**AERONAUTICAL CHARTING MEETING**  
**Charting Group**  
**Meeting – October 24 - 25, 2018**

**RECOMMENDATION DOCUMENT**

**FAA Control #18-02-327**

**Subject:** U.S. Government IAP Chart Modernization

**Visibility with and without ALS**

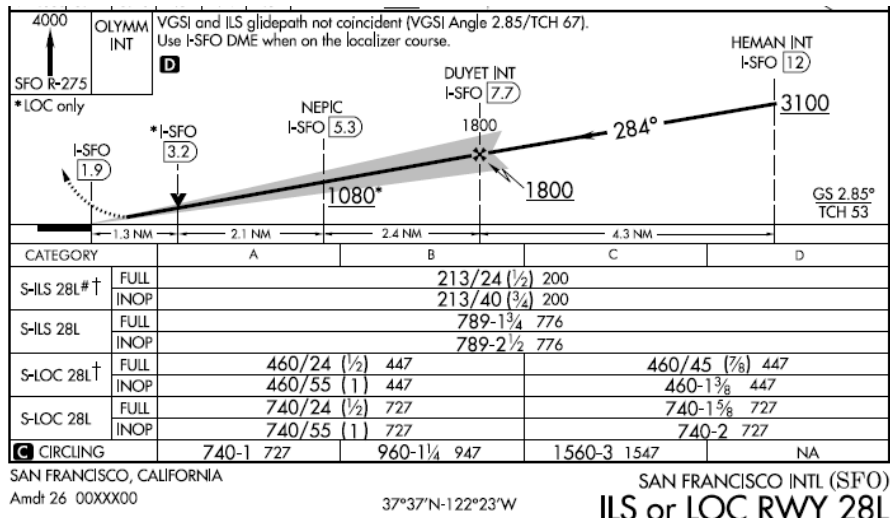
4. Incorporate the effects of inoperative components into the lines of minima for each approach category. The purpose of this proposed change is to furnish the pilot with a Minima Table providing minimums for all situations. Today, the pilot must refer to the Inoperative Components Table of the TPP to determine corrections to the published visibility and to the MDA or DA with the failure of the approach lighting system, runway touchdown zone or centerline lights, or RVR systems. Below is an example of the proposed change:

**SM visibility provided for RVR outage and for military pilots**

1. The “Stacked” option:

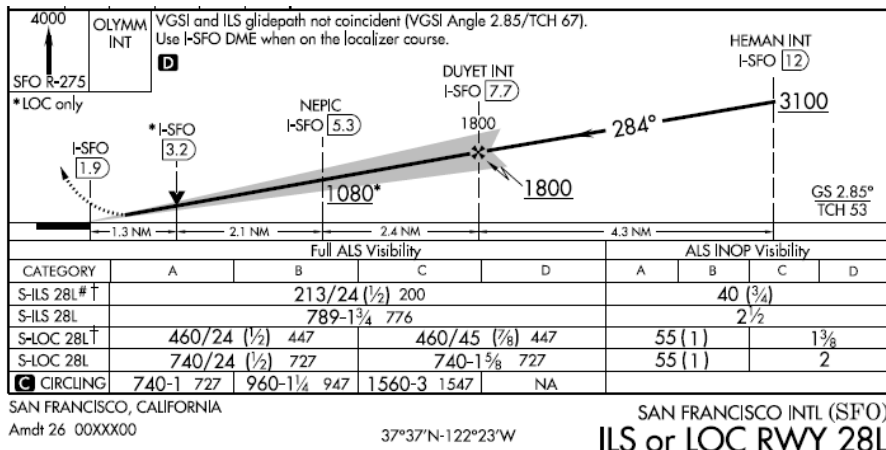
NBAA proposes Two possible presentation options for depicting the lines of minima:
